CEC Comparative Cost of Generation Model

Analysis of Results and Recommended Model Changes

Presentation to IEPR Workshop

Figure 6: Summary of Average Levelized Costs—In-Service 2009

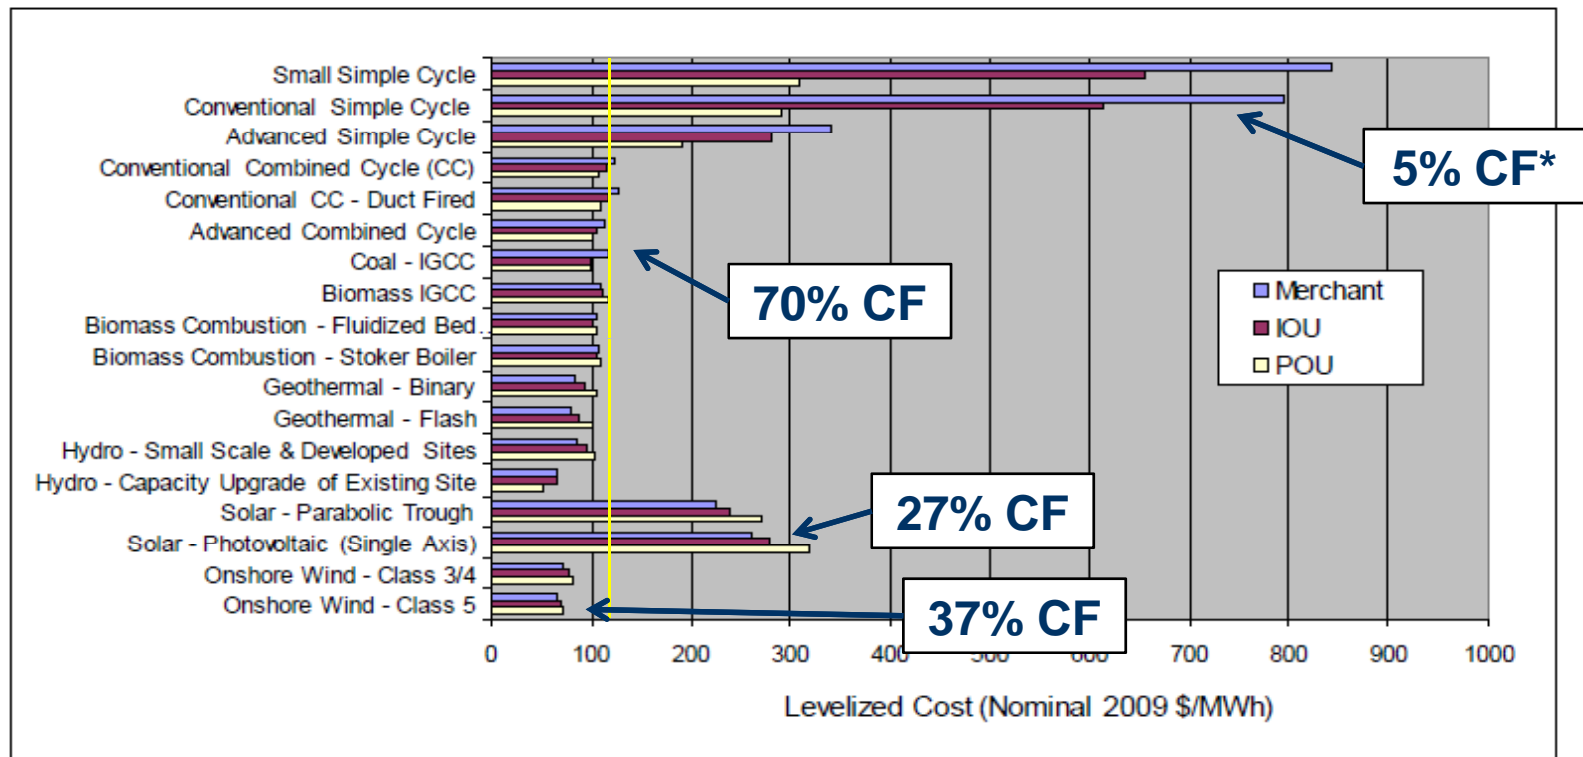
The COG report suggests that the *most* cost-effective resources are hydro and wind, and that the *least* cost-effective resources are solar and combustion turbines.

The existing framework makes it difficult to evaluate cost-effectiveness because:

1. Not all cost elements are included
2. Resources with differing capacity factors are compared on a \$/MWh basis
